Access Compliance Report Public Rights-of-Way (Curb Ramps)

Main Street: ANDAZA_ST		Cross Street: BALIZA_RD		Location:	SE
ADA ID: RPRK211129135125	Ramp Type: Type 4 - Parallel	Initial Pass/Fail: Fail	Overall Compliance: No	Severity Score:	32
Codes/Mitigation Info/Possible Solution			Field Measurements/Component Compliance

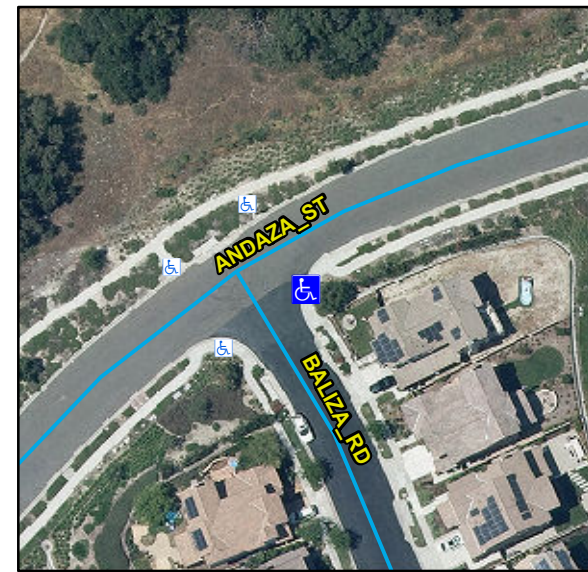
R304.3.2, R304.5.3, STD 1115

Remove & Replace Curb Ramp With Two New Directional Ramps or Equivalent.
